RE: JMC Project 19124
#100-Building 2
100 Business Park Drive
Town of North Castle, NY

Response to Town Comments Submission

Town of North Castle Planning Department Memorandum, dated April 10, 2020

INFILTRATION BASIN 'A' CROSS SECTION

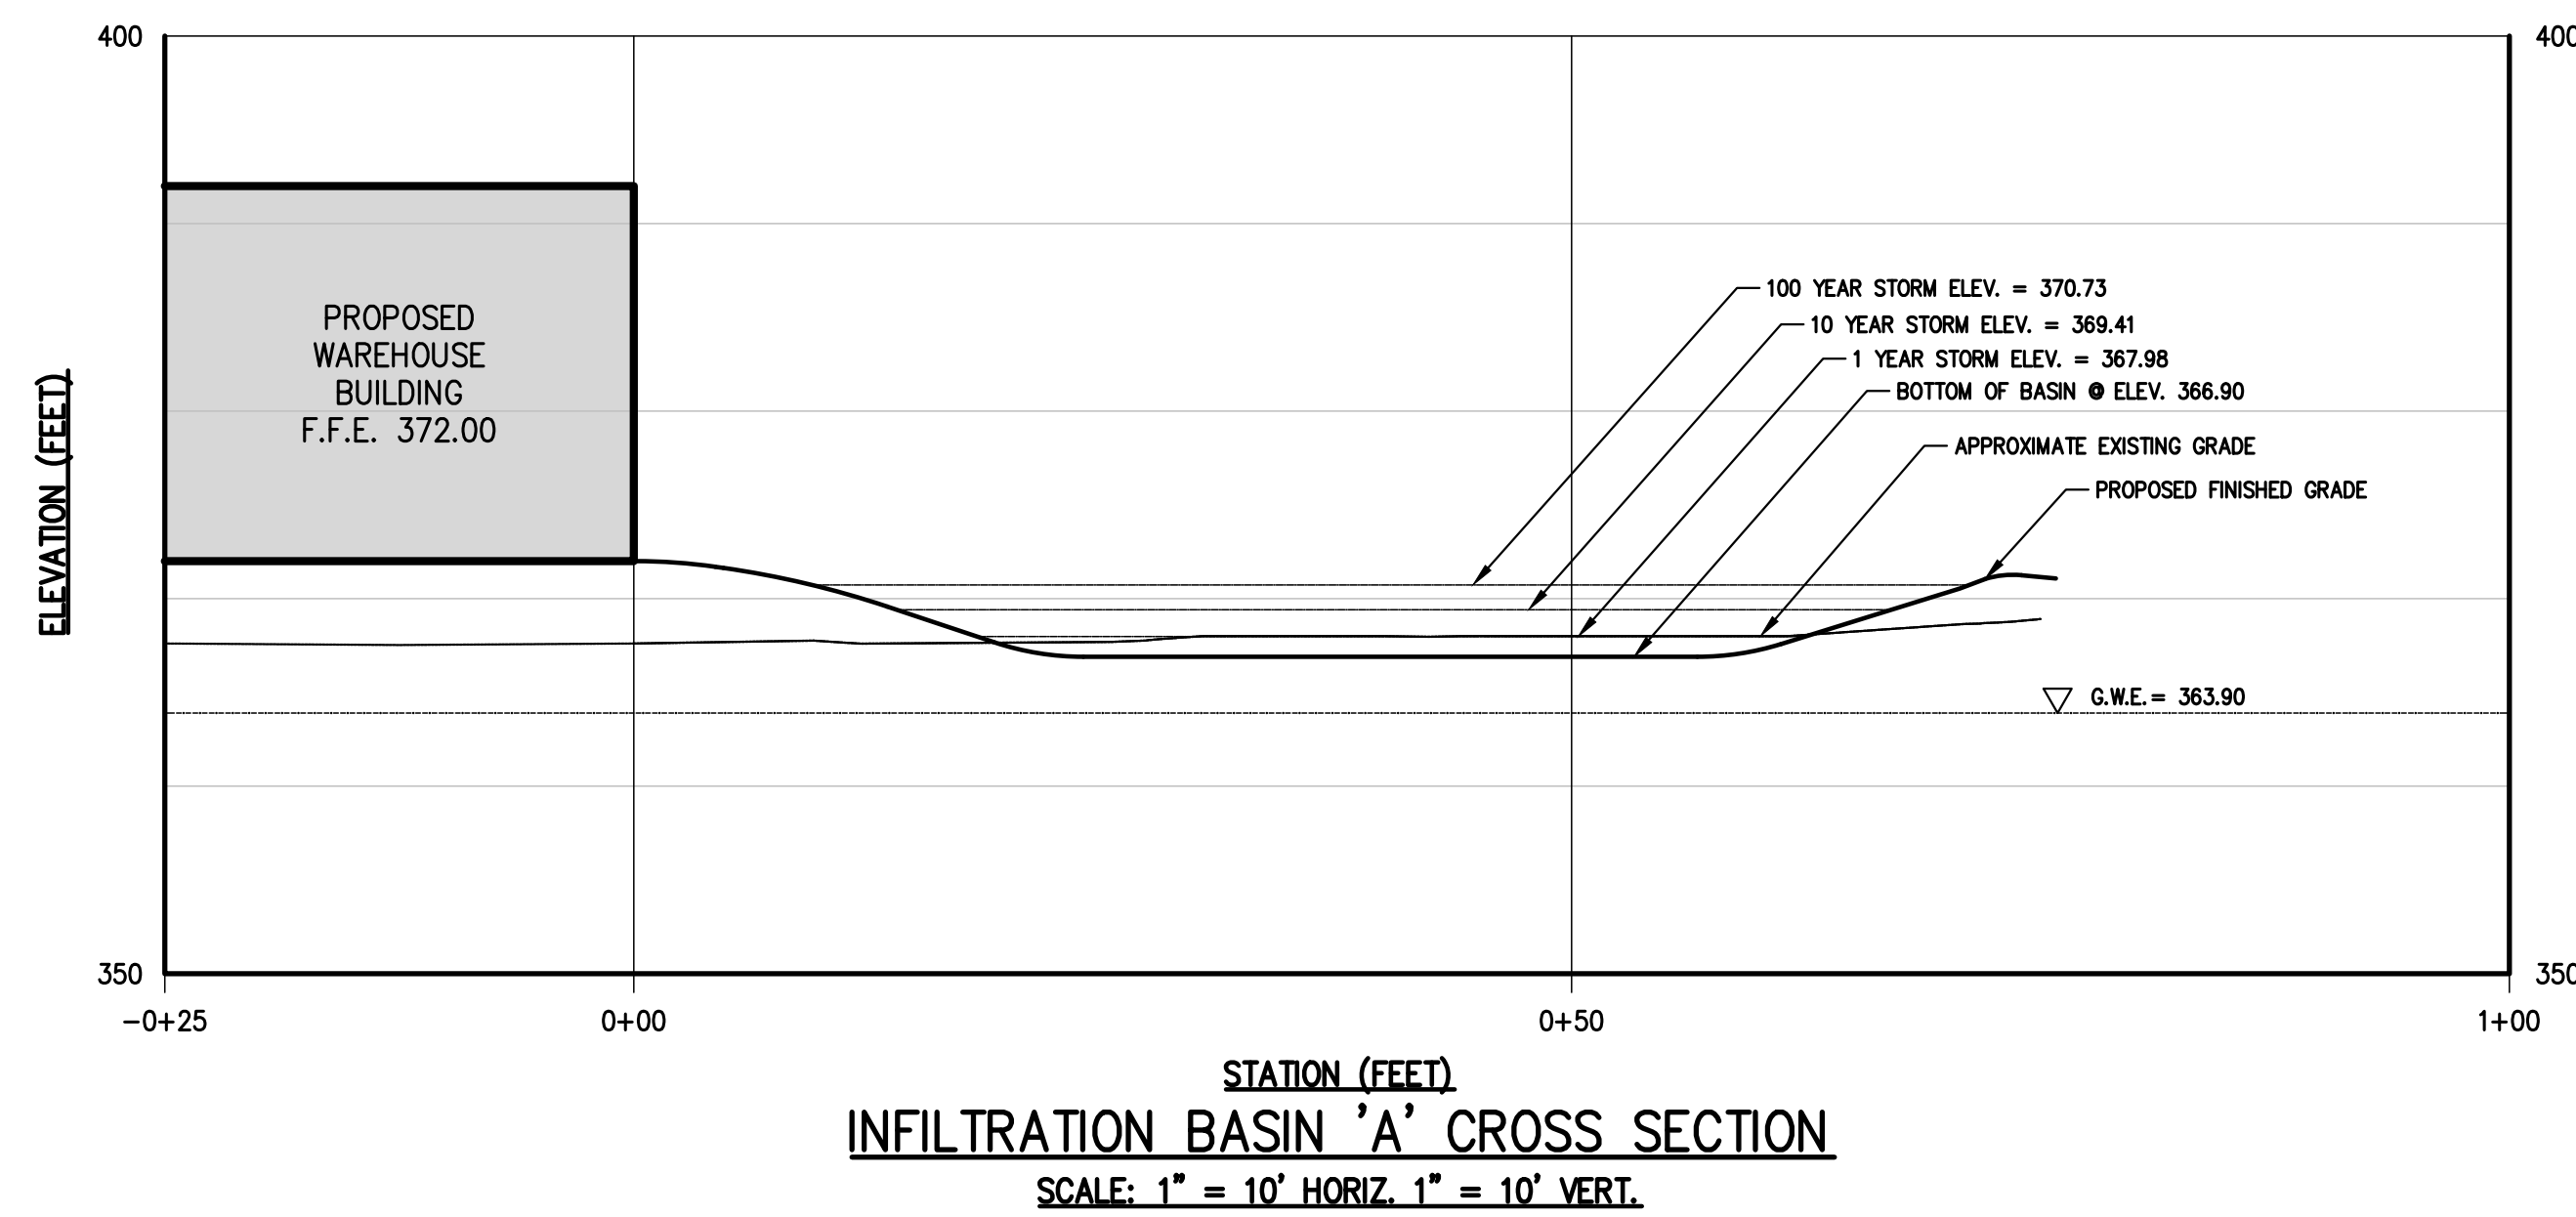
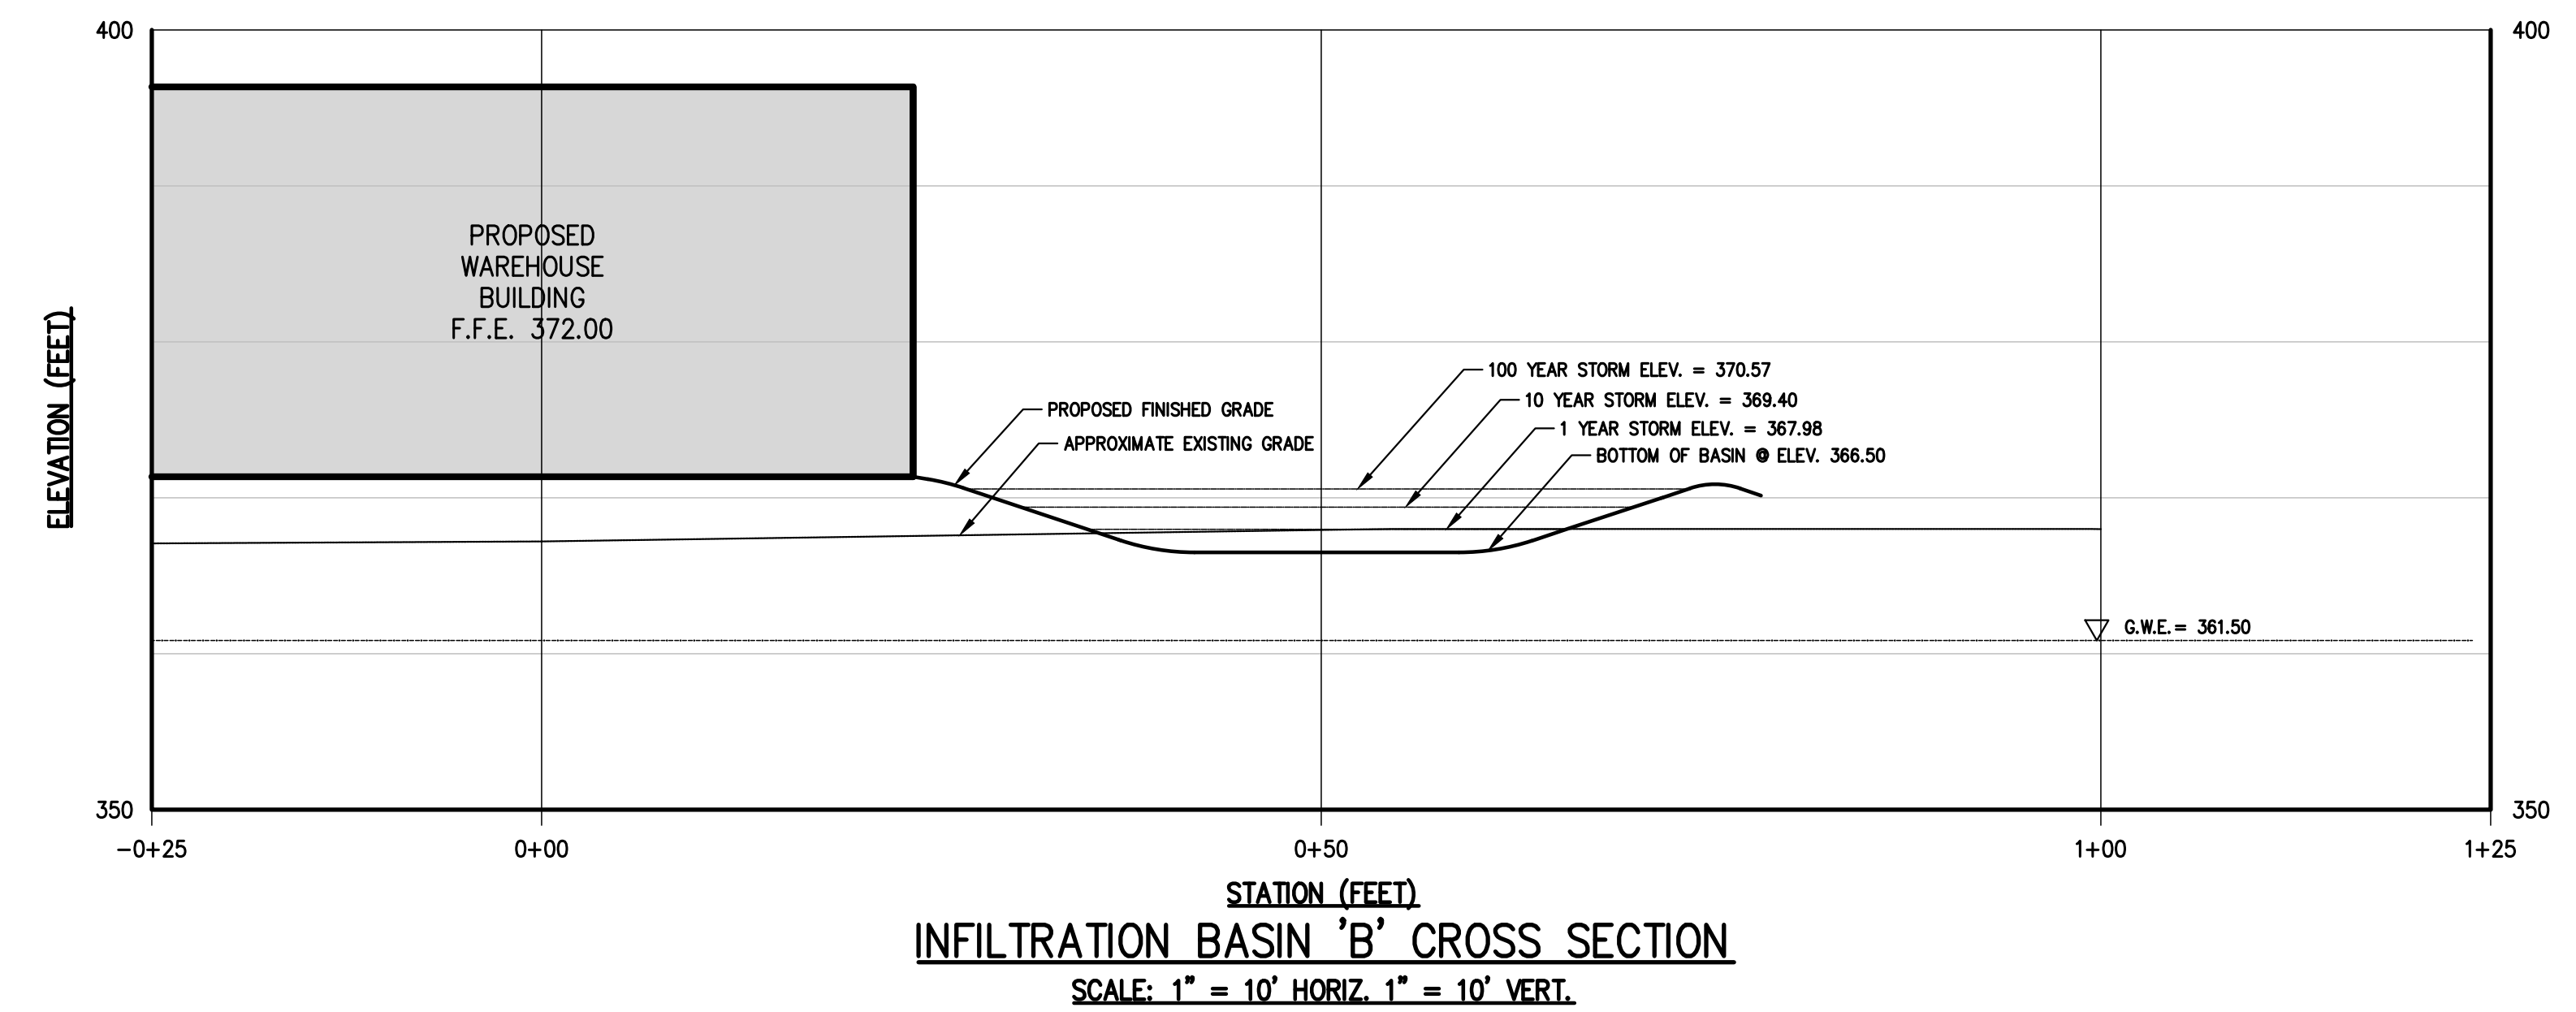
The plan proposes approximately 4.8 acres of disturbance, which will require the owner to obtain coverage under the NYSDEC General Permit (GP-0-20-001) for Stormwater Discharge from Construction Activities. The applicant has prepared a Stormwater Pollution Prevention Plan (SWPPP) and Erosion and Sediment Control Plan for review. We will defer a detailed review of the SWPPP until the plan is developed further. However, we offer the following preliminary comments for consideration:

- g) Cross sections of the stormwater basins have been prepared and are provided on JMC Drawing C-904. These cross sections depict the infiltration basins and include the water surface elevations during the 1, 10, and 100 year storm events.
